Dear Reviewer 1,

Thank you for reviewing our manuscript and for providing useful comments. Below, we have outlined the replies to your comments. Also, we revised our manuscript based on your comments.

Fig. Geologic logs of the monitoring wells.

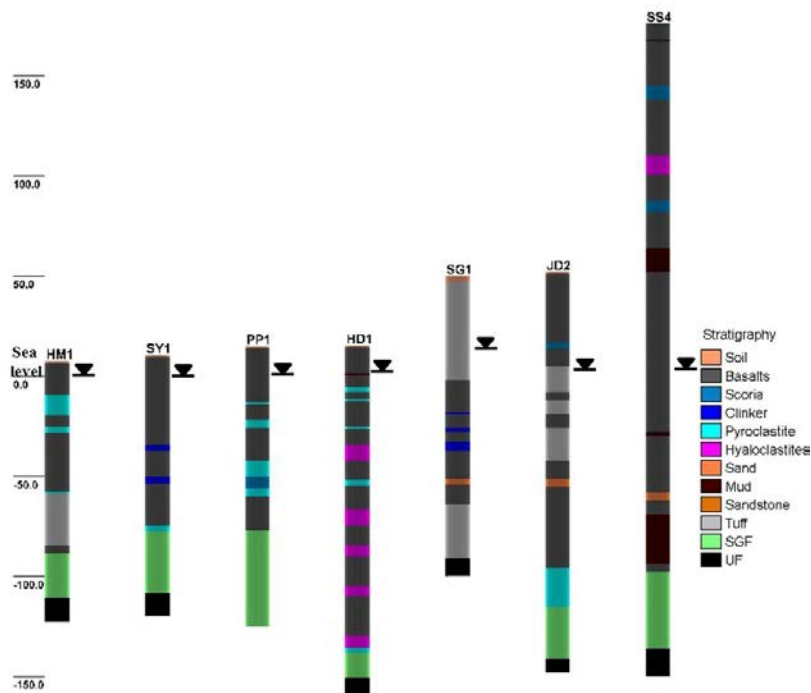
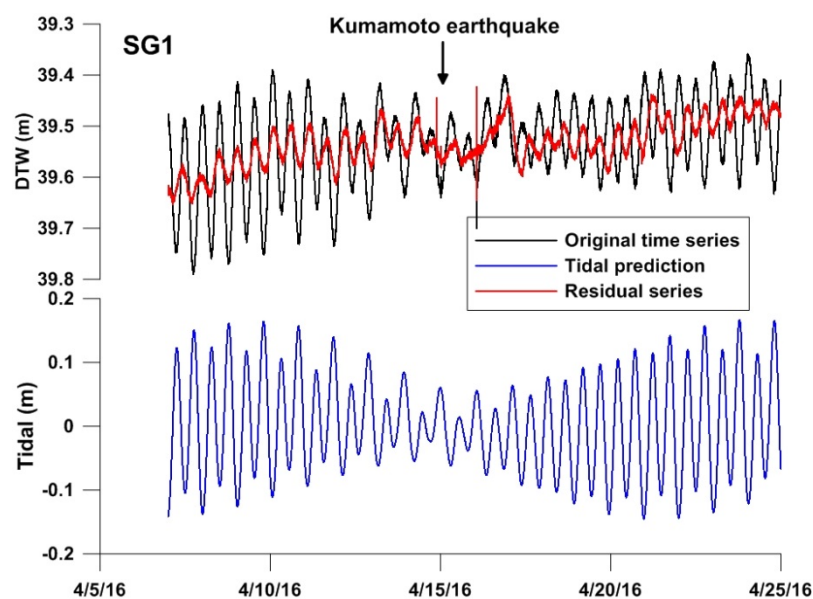
(1) The authors described the lithology and groundwater wells in Jeju Island, but no information is provided about aquifer and the well structure of these wells. I suggest that a cross-section of the hydrogeology setting with location of these wells would be insightful.

- We agree with your comments. Accordingly, we added Fig. 2 (Geologic logs of the monitoring wells). As described in the revised manuscript (the lines 4 - 9 on the page 3), based on the geological logs of the monitoring wells that are mostly drilled to UF (Unconsolidated Formation), porous lava flows of repeatedly accumulated layers cover the basement rocks. Especially, in the higher altitude area, more abundant lava flows appear with the existence of many volcanic units (including clinker, scoria, sediments, pyroclastites, and hyaloclastites etc.) between the lava flows. Consequently, groundwater moves along complicated flow paths under the influence of numerous hydraulic parameters.

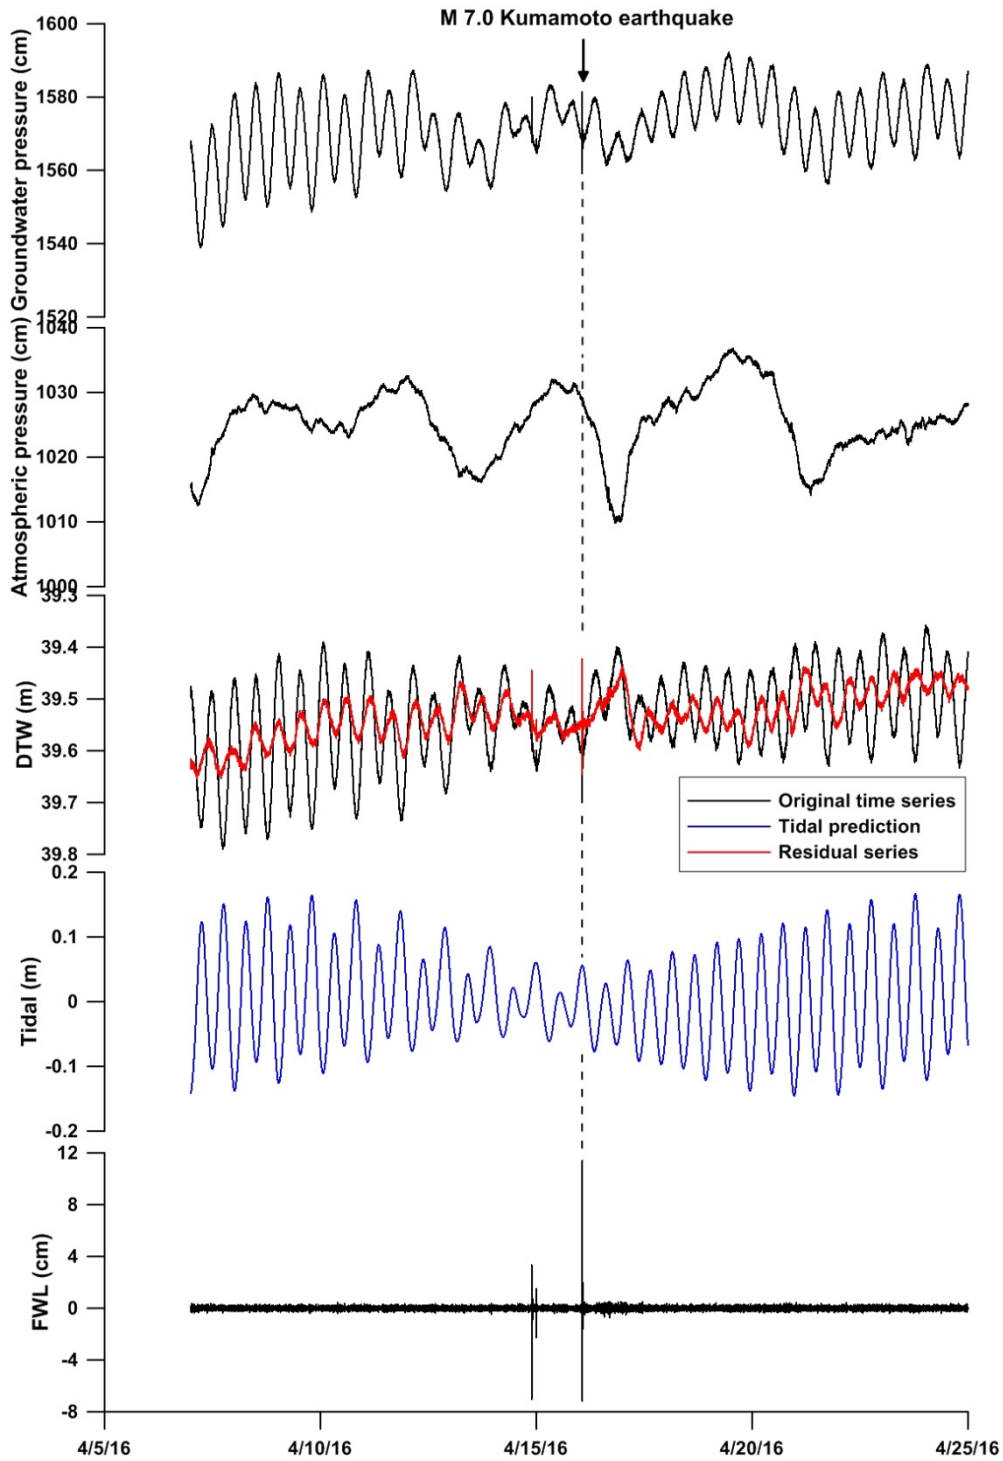
(5) The author said  $X_t$  is the raw groundwater level corrected for atmospheric pressure, but they didn’t show what method was used in the correction.

- The raw groundwater level was corrected for barometric pressure effect, by simultaneous atmospheric pressure measurement with the groundwater level measurement. Please refer Fig. 3.
